USB Power Delivery ENGINEERING CHANGE NOTICE

Title: Correction to BMC description

Applied to: USB Power Delivery Specification Revision 3.2

Figure 5-1 “Transmitting or Receiving BMC Encoded Frame Terminated by Zero with High-to-Low Last Transition”

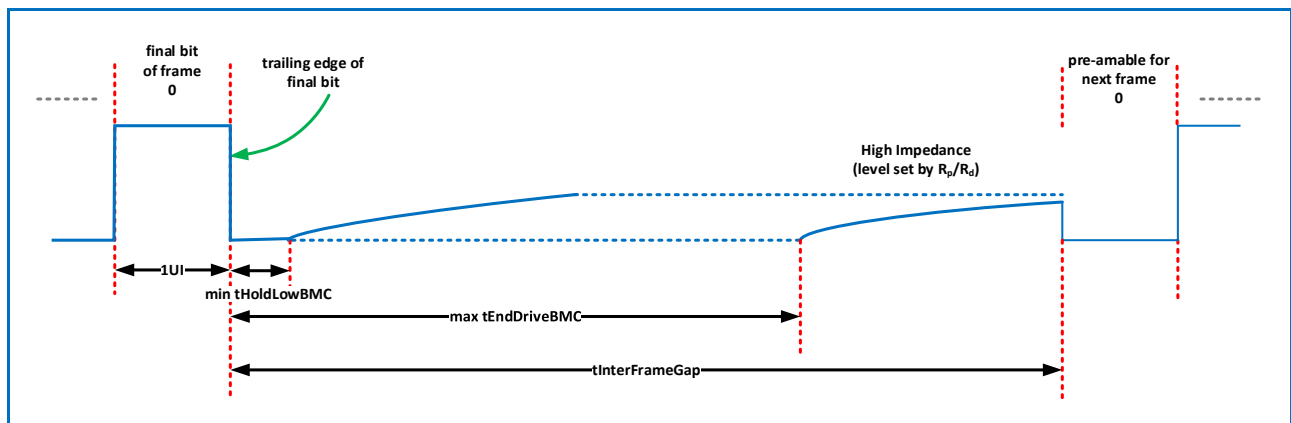
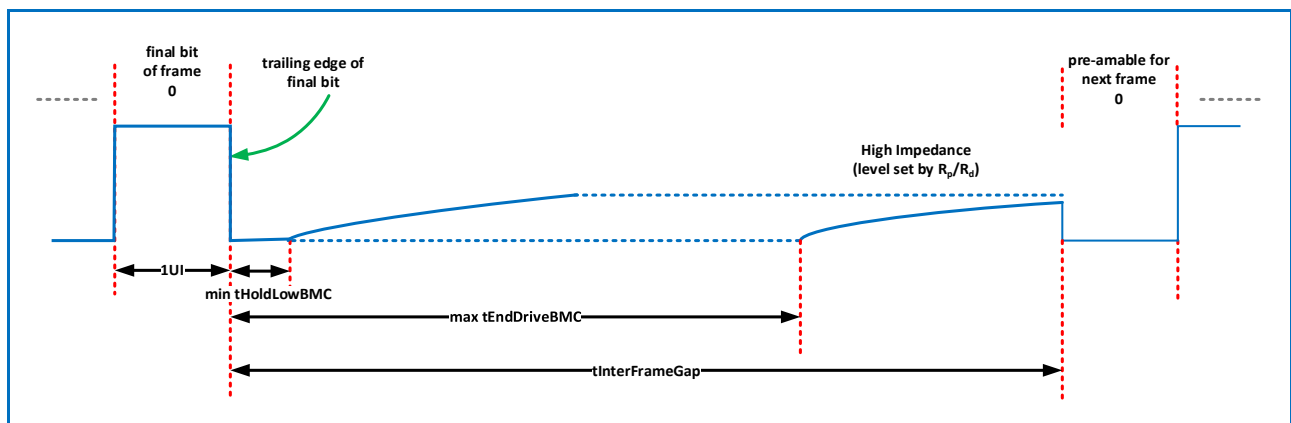
| This ECN has no functional change but is a correction to the language in the description of the timing between BMC packets. This text was incorrect from the very first appearance in the spec. Every known implementation does it the way the drawing shows - which is correct. |

The transmitter **Shall** terminate the final bit of the Frame by an edge (the “trailing edge”) to help ensure that the receiver clocks the final bit. If the trailing edge results in the transmitter driving CC low (i.e., the final half-UI of the frame is high), then the transmitter:

- **Shall** continue to drive CC low for ***tHoldLowBMC***.
- Then **Shall** continue to drive CC low for ***tEndDriveBMC*** measured from the trailing edge of the final bit of the Frame.
- Then **Shall** release CC to high impedance.

The transmitter **Shall** terminate the final bit of the Frame by an edge (the “trailing edge”) to help ensure that the receiver clocks the final bit. If the trailing edge results in the transmitter driving CC low (i.e., the final half-UI of the frame is high [see figures 5.11 and 5.12](#)), then the transmitter:

- **Shall** continue to drive CC low for min ***tHoldLowBMC***.
- **Should** release CC to high impedance as soon as possible after min ***tHoldLowBMC*** and **Shall** release CC by max ***tEndDriveBMC***.

Figure 5-3 “Transmitting or Receiving BMC Encoded Frame Terminated by Zero with Low to High Last Transition”

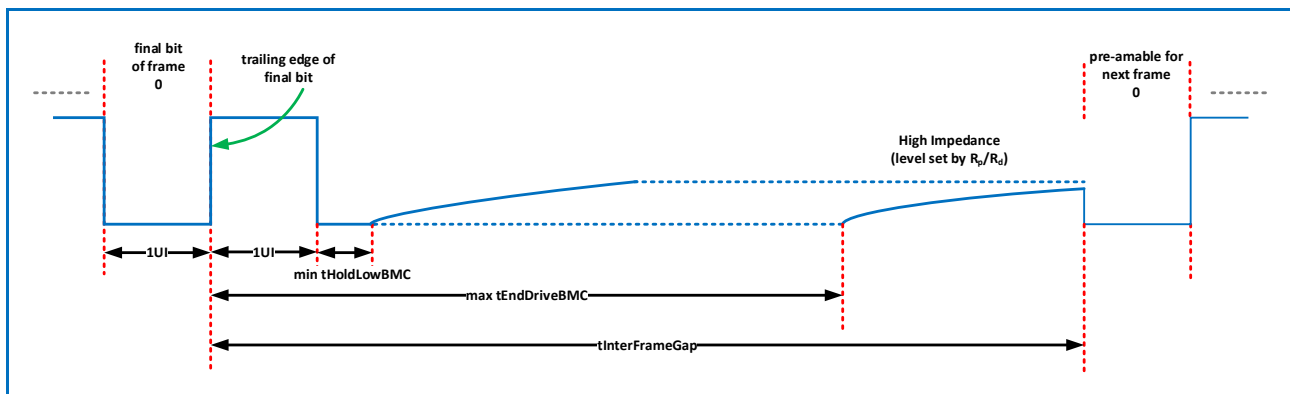
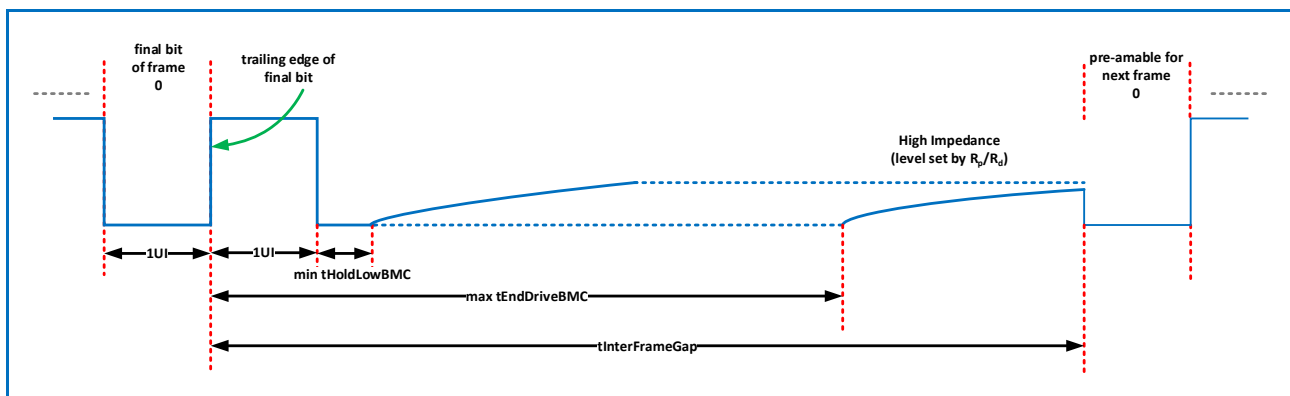
If the trailing edge results in the transmitter driving CC high (i.e., the final half-UI of the frame is low), then the transmitter:

- **Shall** continue to drive CC high for 1 UI.
- Then **Shall** drive CC low for $t_{HoldLowBMC}$.
- Then **Shall** continue to drive CC low for $t_{EndDriveBMC}$ measured from the final edge of the final bit of the Frame.
- Then **Shall** release CC to high impedance.

If the trailing edge results in the transmitter driving CC high (i.e., the final half-UI of the frame is low see figure 5.13 and 5.14), then the transmitter:

- **Shall** continue to drive CC high for 1 UI.
- o Then Shall drive CC low for $\min t_{HoldLowBMC}$.
- **Should** release CC to high impedance as soon as possible after $\min t_{HoldLowBMC}$ and **Shall** release CC by $\max t_{EndDriveBMC}$.
